DEPARTMENT OF PLANNING AND ZONING PLANNER'S REPORT

DATE: July 24, 2019
TO: Tonya Hutson
FROM: Michael Smith
VIA: Lynn Patterson

RE: Design Inspection – 491 Walnut Street –

Revised BACKGROUND

Front façade (taken 7/23; updated with walkway, landscaping, light and street numbers at door)

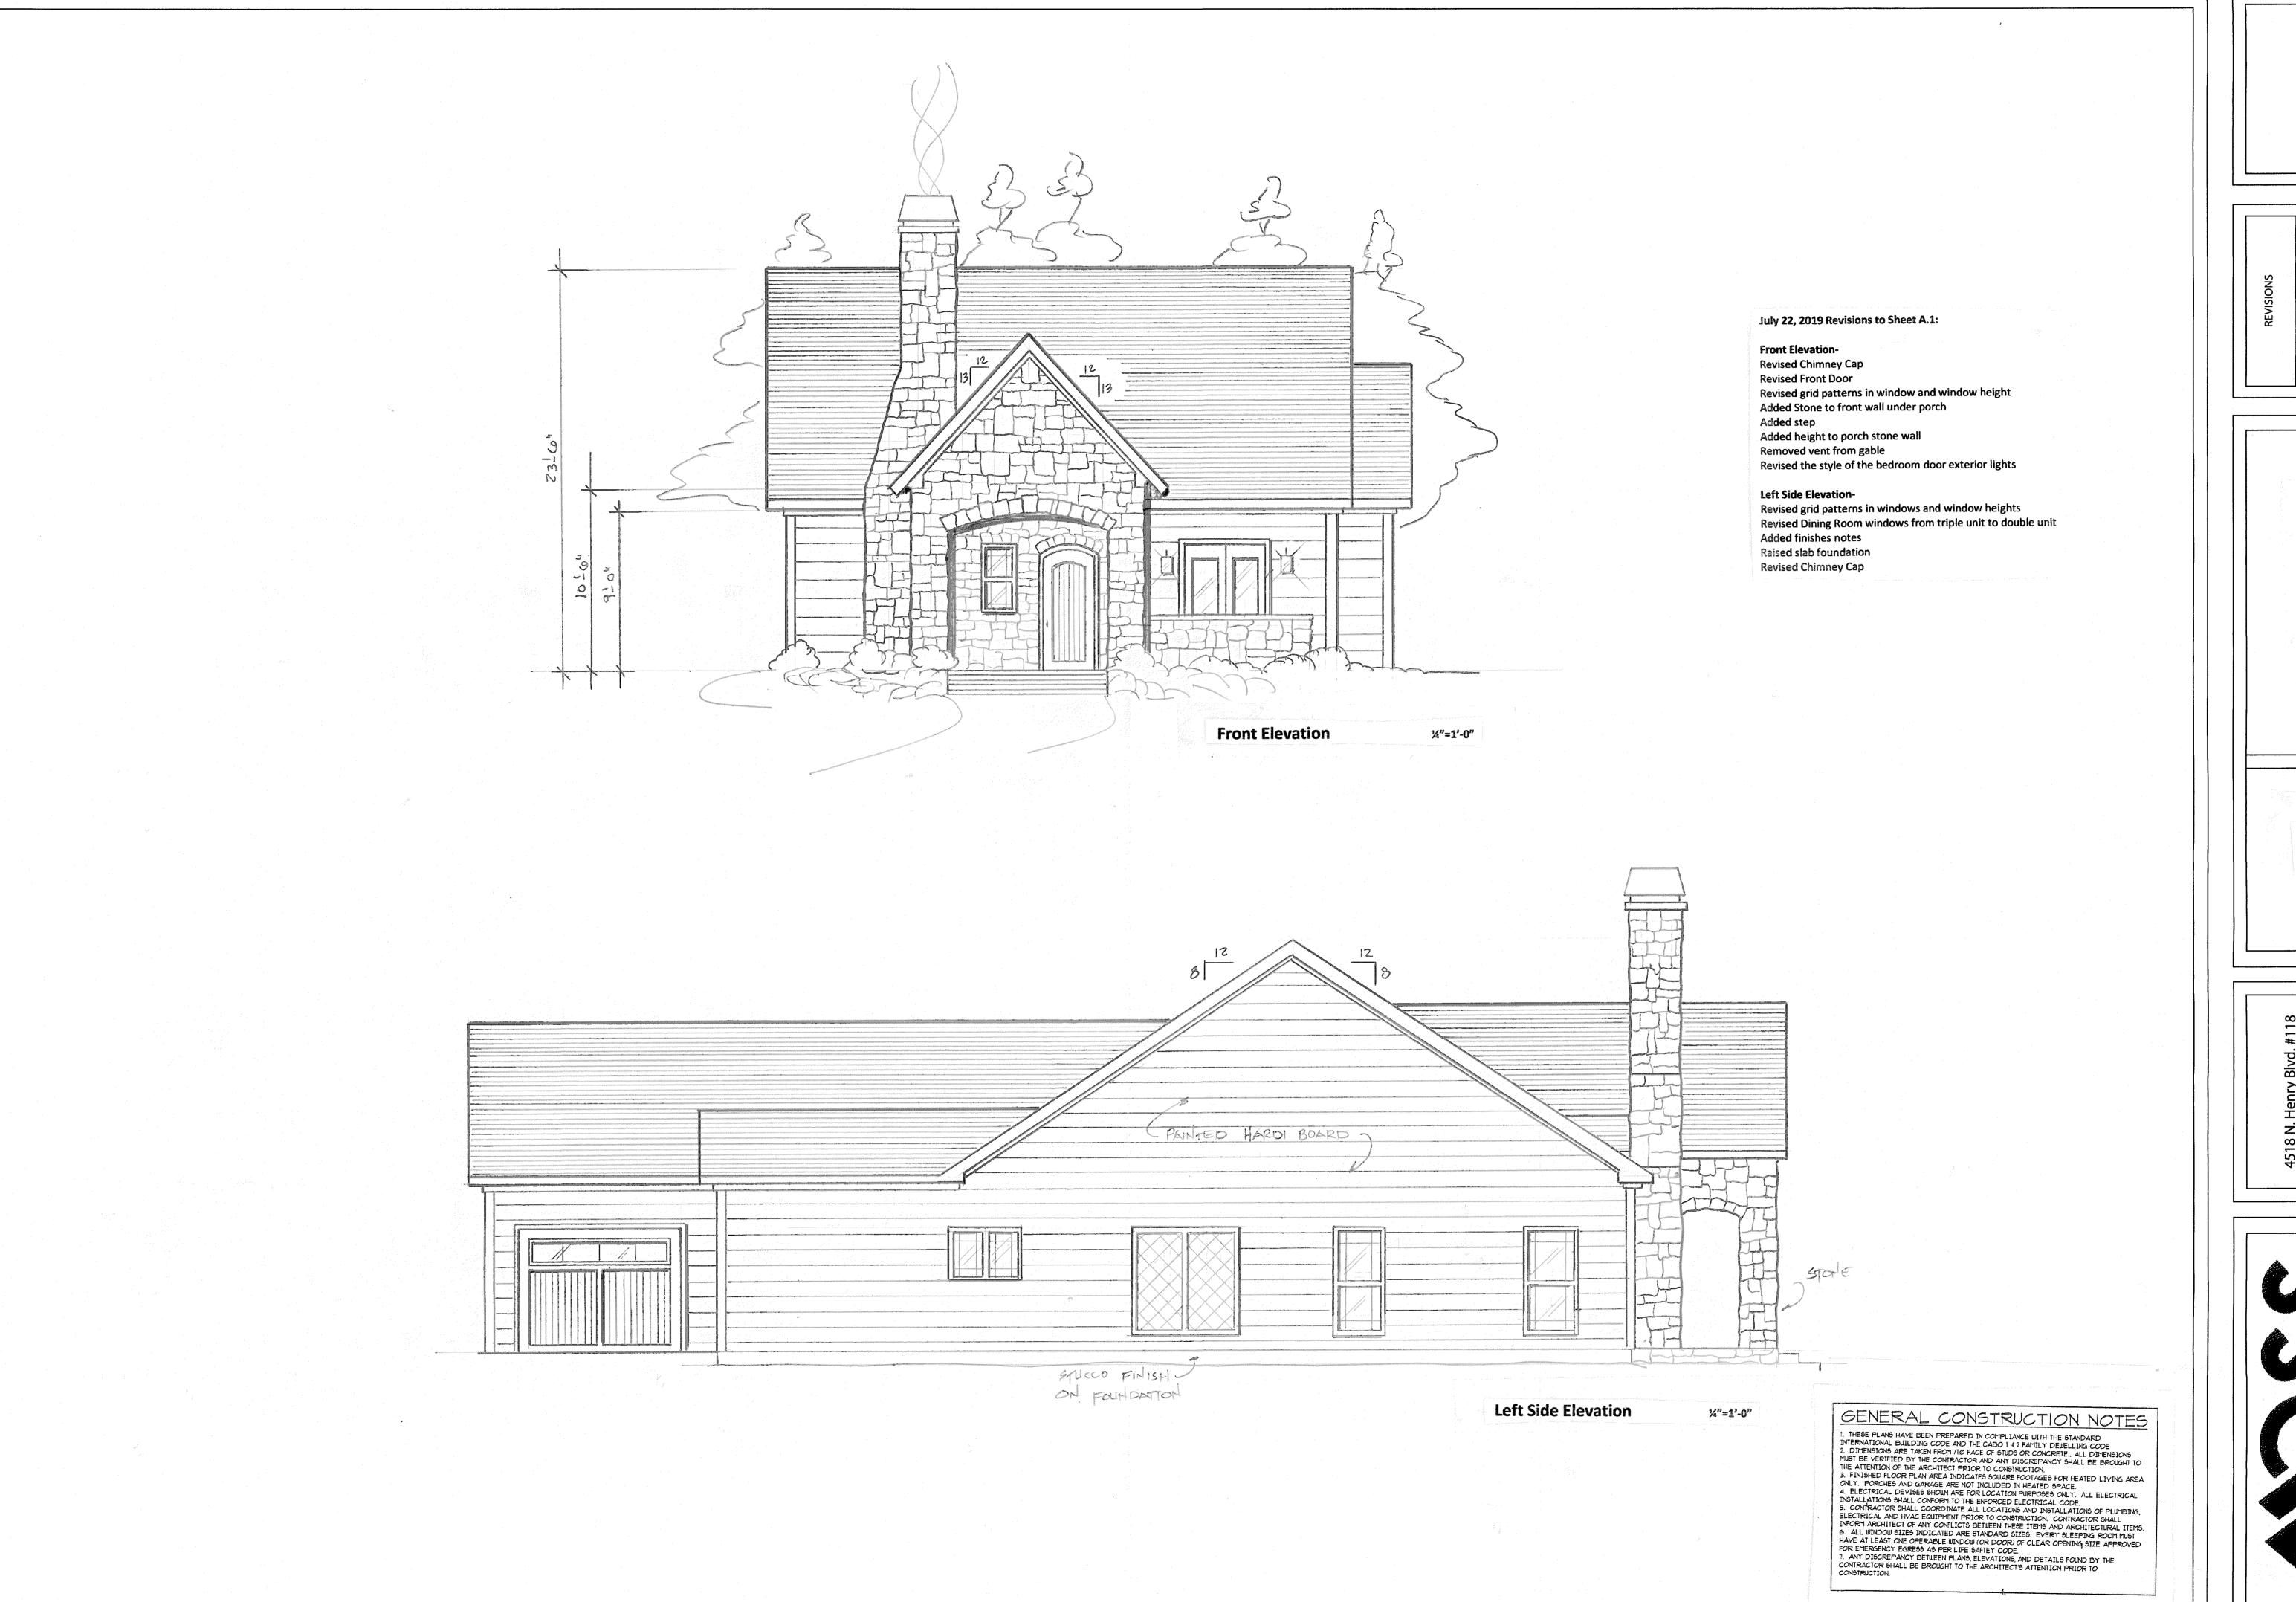
4. The number, style, size, and placement of windows are not consistent with the approved plans and are no longer at the same heights.

9. The front door is a different style than what is in the approved designs.

10. The house is now raised, and steps have been added to the porch.

This is correct, after meeting with the window company and laying everything out, the windows we installed provide more natural light and a beautiful architectural design that go with the Tudor style of this home. These windows cost double the price of standard windows and we've received nothing but compliments from the neighbors and contractors. We would like the committee to vote that we are allowed to keep the windows in the revised plans. (Revised plans and pictures provided)

Correct, after meeting with the door/lumber company and laying everything out, we felt this door added beautiful architectural design that goes with the Tudor style of this home. This door cost triple the price of a standard door and again, we've received nothing but compliments from the neighbors and contractors. We would like the committee to vote that we are allowed to keep this door as it is. (Revised plan and picture)

Correct, this keeps us above the flood level and adds a beautiful front elevation, our neighbor at 493 also made this decision with their new home. With 493 being elevated we would have set far below them and would have faced a major run off problem if not elevated. We would like the committee to vote that we are allowed to keep this as it is. (Revised plan and picture provided)

Α.1

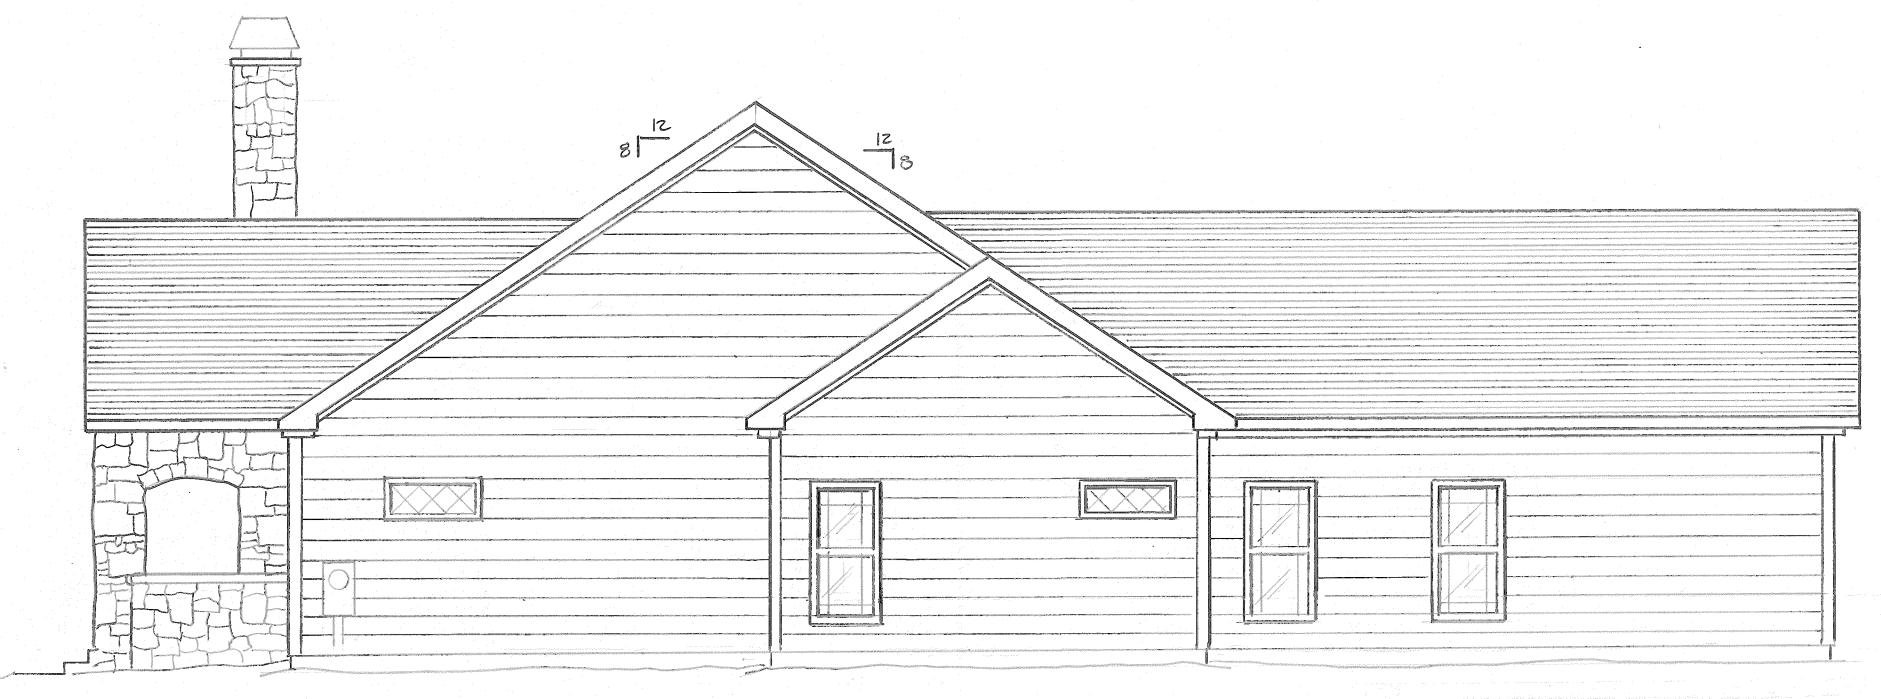
7. The height and style of the chimney do not conform to the approved designs (*this change was made to conform with requirements of the fire safety code*).

The chimney was constructed per all necessary the building and safety codes. We would like the committee to vote that we are allowed to keep this as constructed. (Revised plans and picture provided)

July 22, 2019 Revisions to Sheet A.2

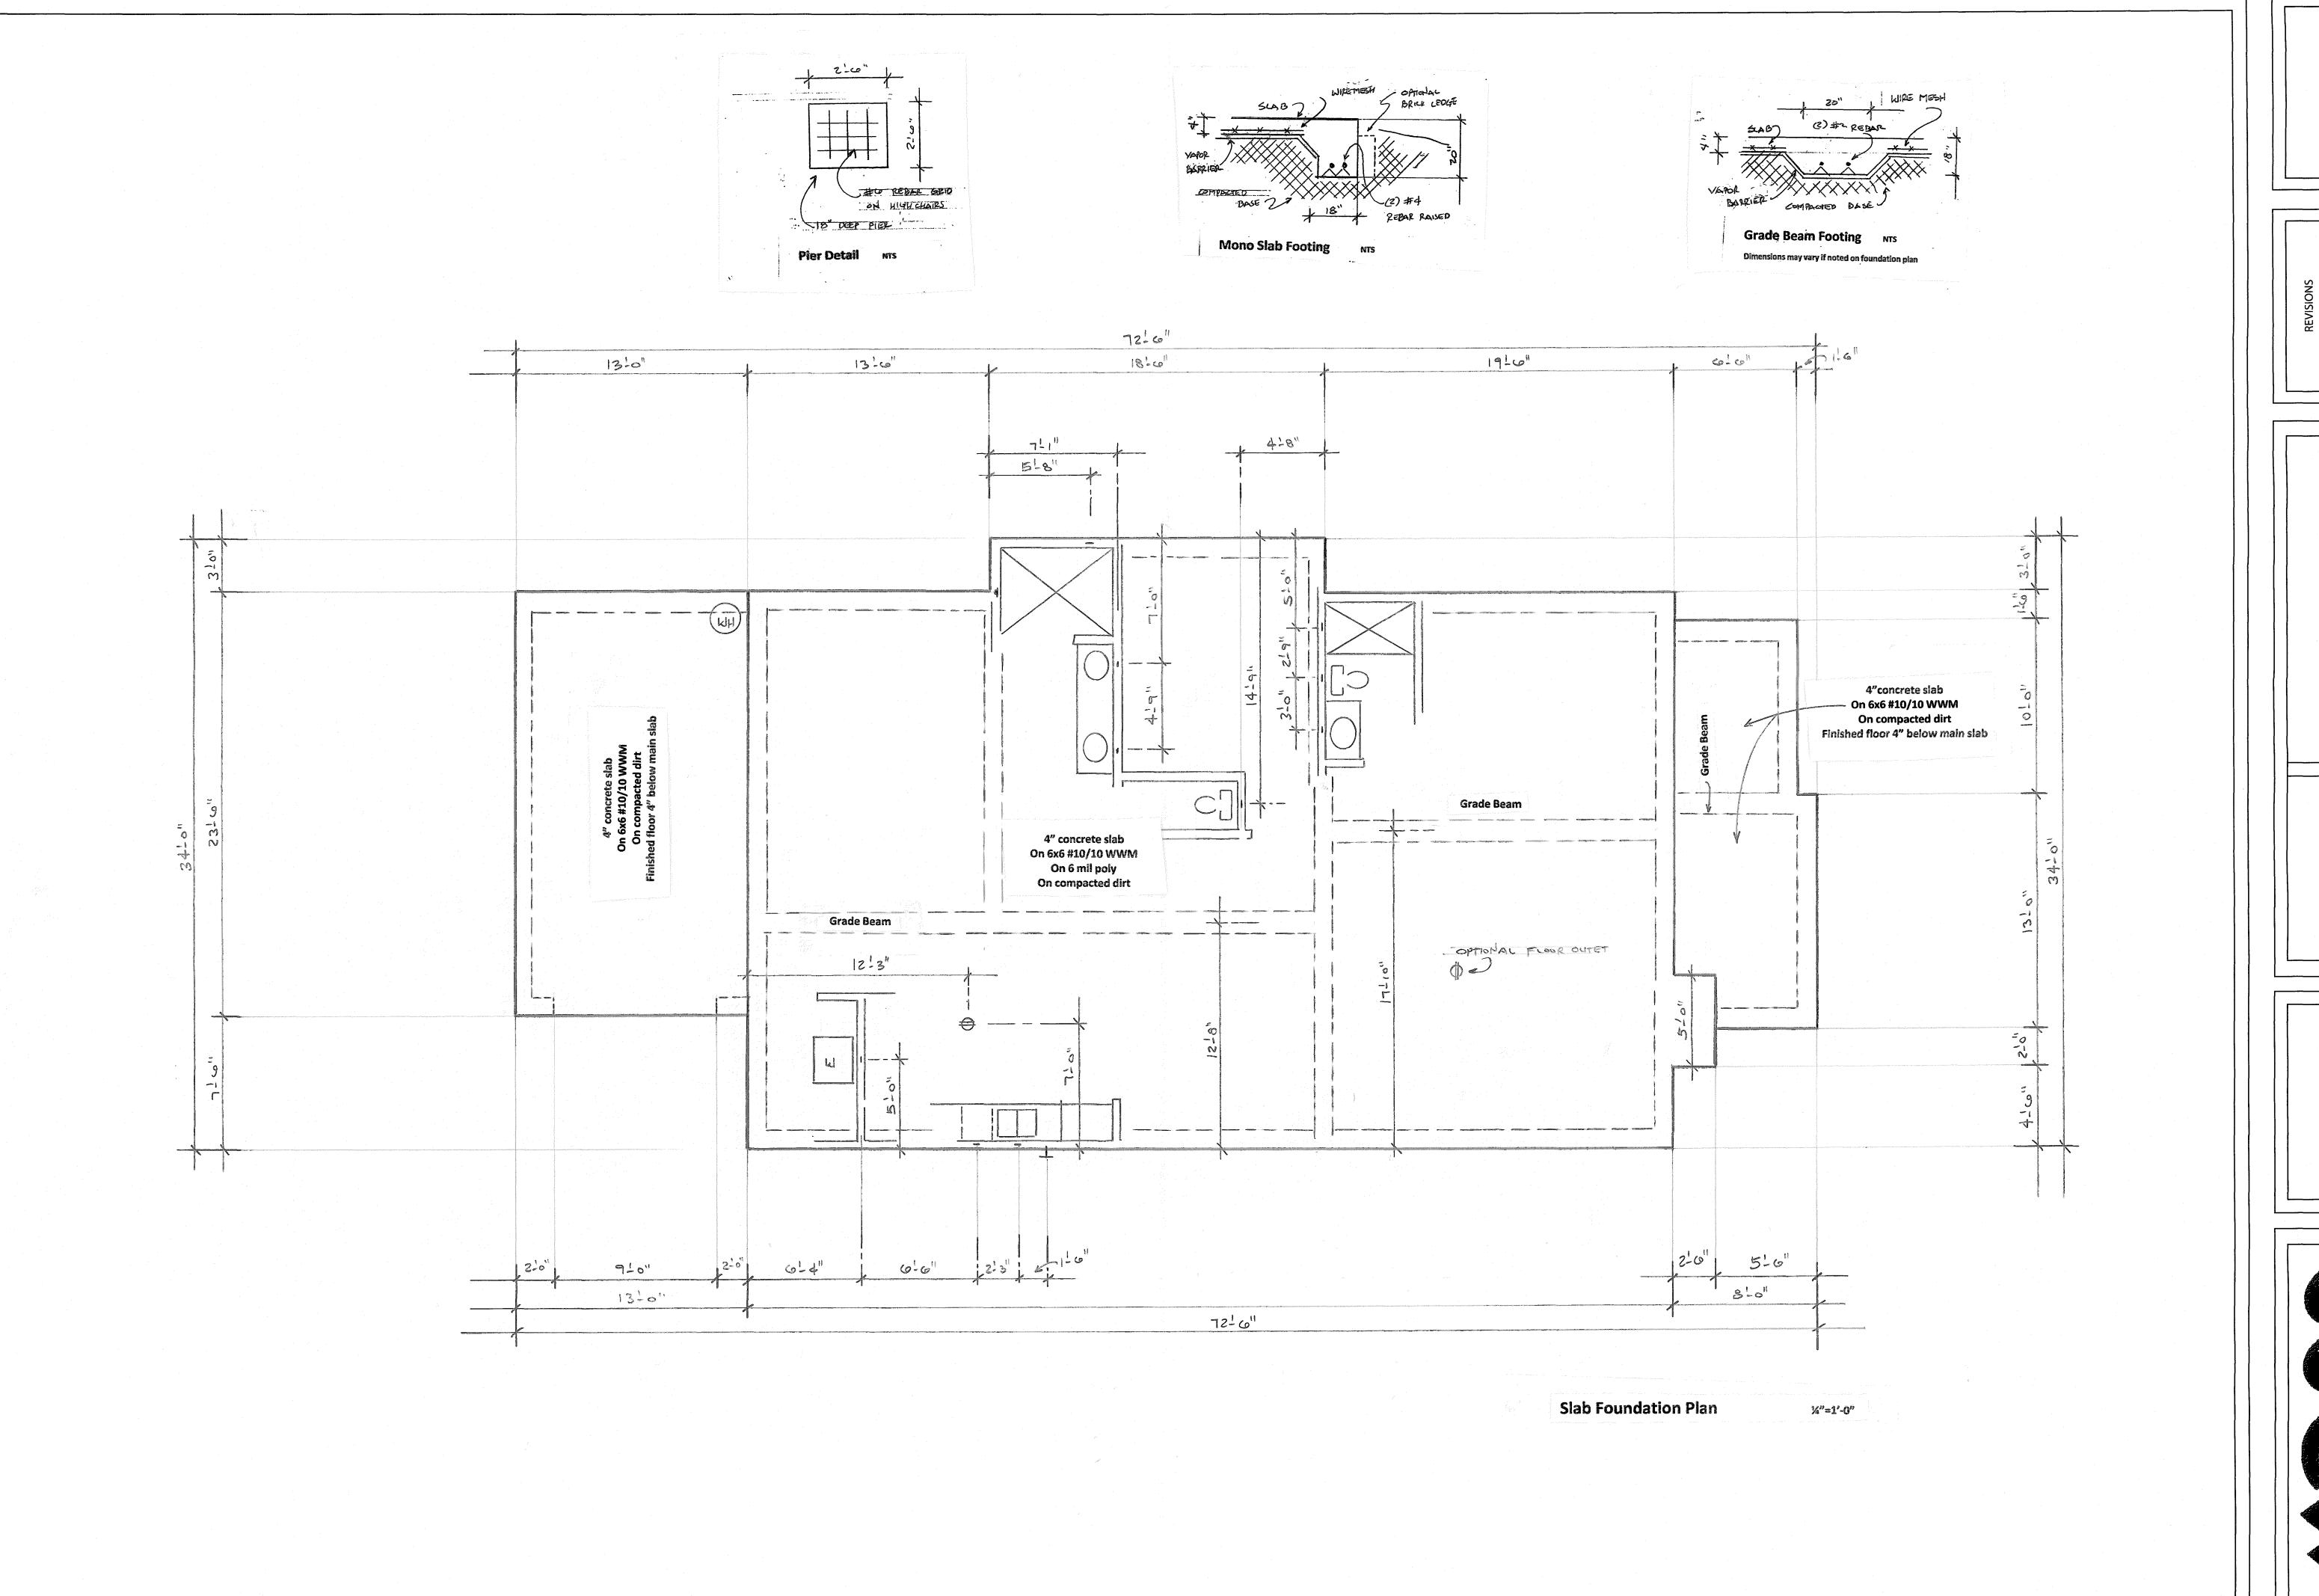
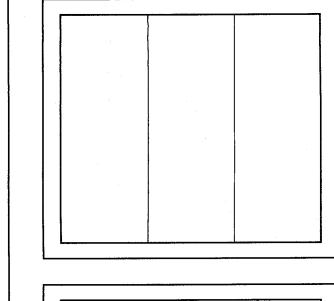
5. There is a rear entrance not shown on plans.

Right Side ElevationRevised Chimney Cap
Raised Height of front porch wall
Added transom window to the front bedroom
Revised grid patterns in windows and window heights
Raised concrete slab foundation

Rear ElevationAdded garage walk thru door
Revised grid in windows and window height
Revised chimney
Raised concrete slab foundation
